University of California, San Francisco

Acoustics TPC Evaluation

Issued: 25 January 2024

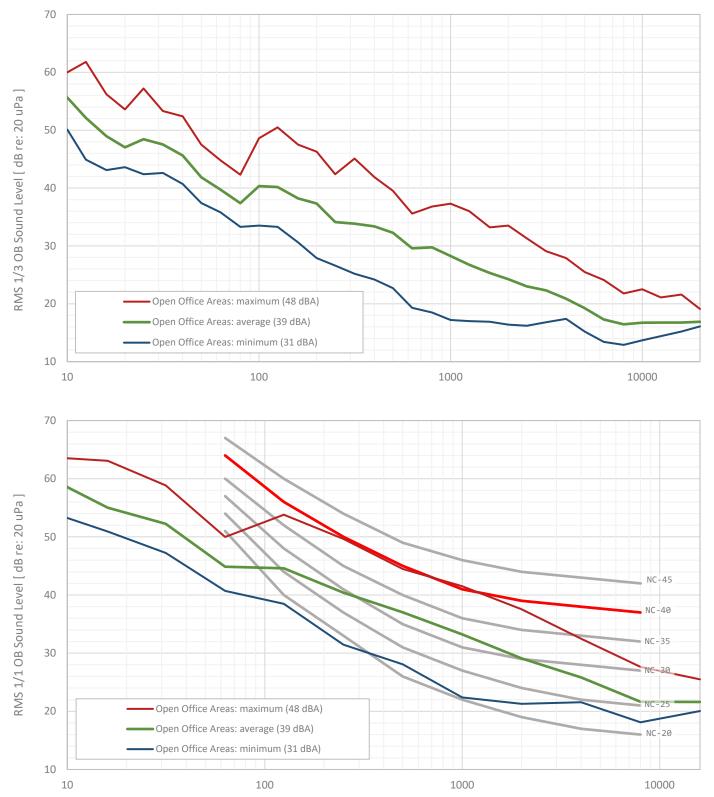
Average noise levels across the open office areas are NC-32, due to the room HVAC system. In general, open office areas in both Block 33 and Weill had very low background noise levels, resulting in reduced speech privacy.

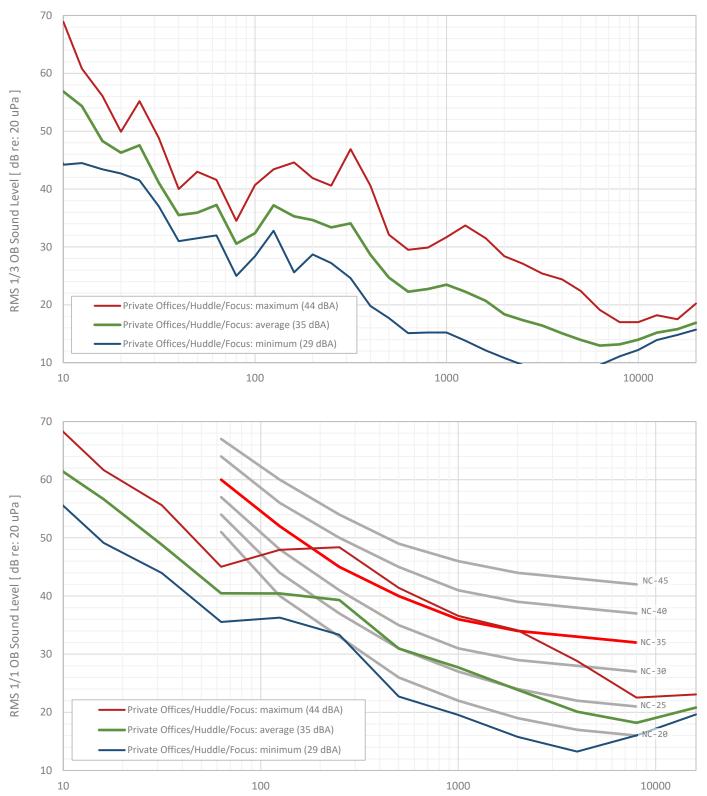
Average noise levels are NC-28, due to the room HVAC system; however, noise levels at higher and lower frequencies are far below the NC-35 TPC target. In general, background noise levels in office spaces are too low, resulting in reduced speech privacy.

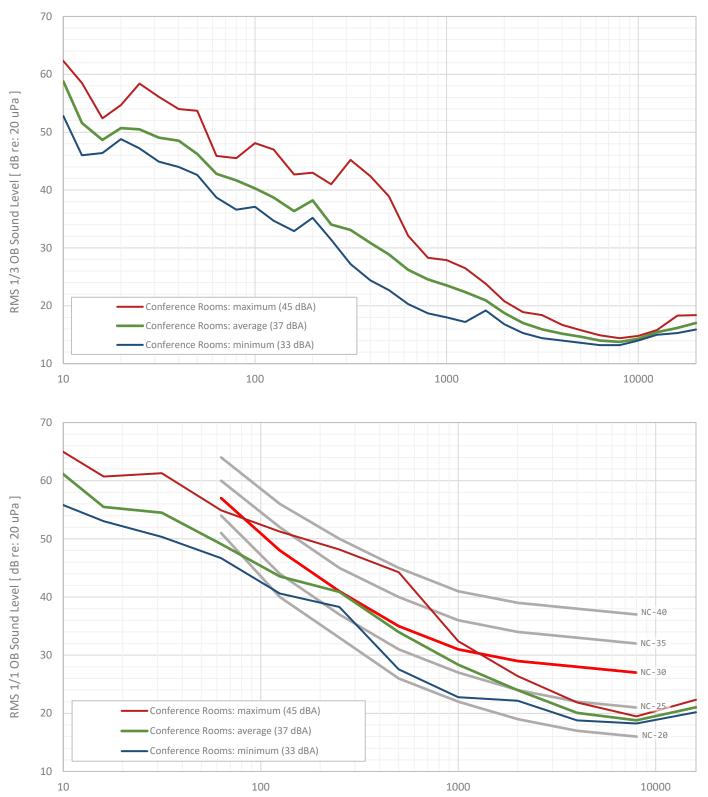
Average noise levels are NC-30, due to the room HVAC system; higher sound levels in Mission Hall 2700 appear to be caused by a particularly noisy UFT device.

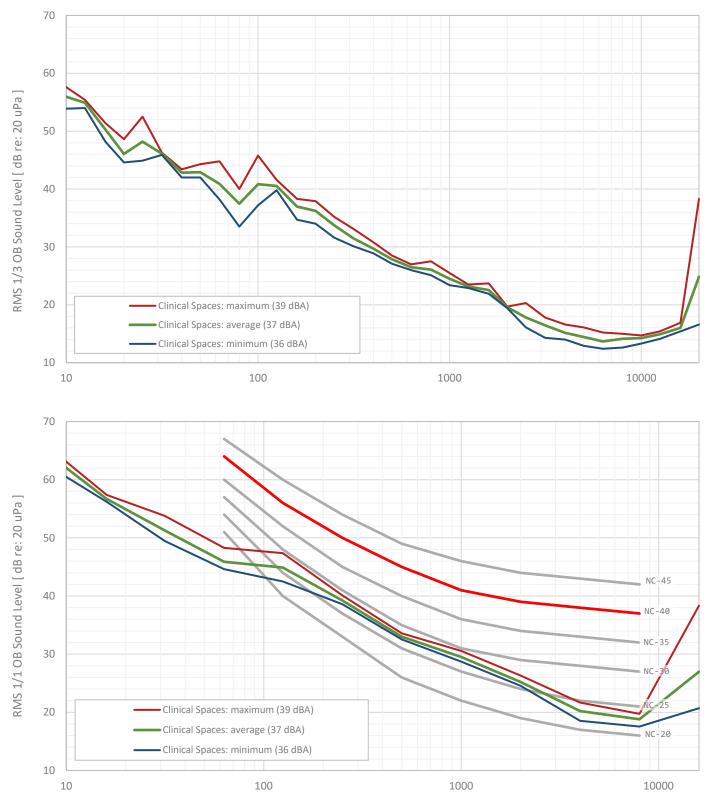
Average noise levels are approximately NC-28, due to the room HVAC system. The background noise levels in these rooms are well below the TPC target of NC-40 and result in significantly reduced speech privacy.

Figure B.3: Results from Mission Hall 2700 (conference room)

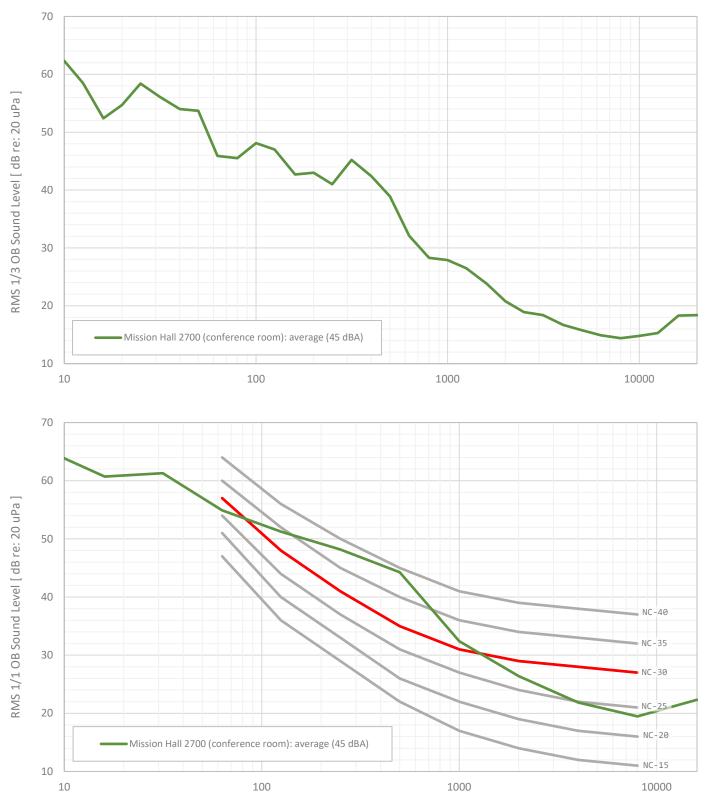
Noise levels are NC-39: HVAC ON in normal mode; floor vents at north end of room are dominant

Figure C.3: Noise reduction of partition between Weill 254A and Weill Corridor

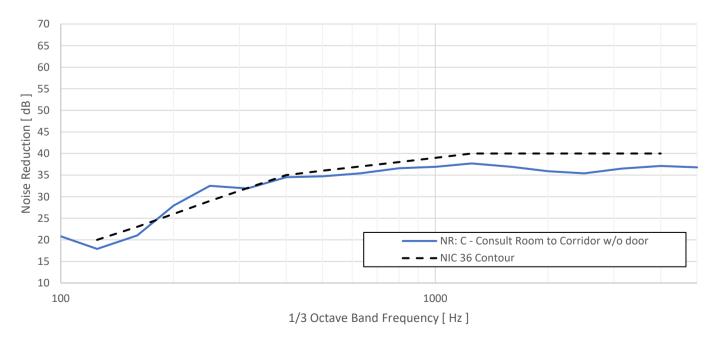
corridor to plan north, minor sound leak at extinguisher cabinet; partition meets NIC-36
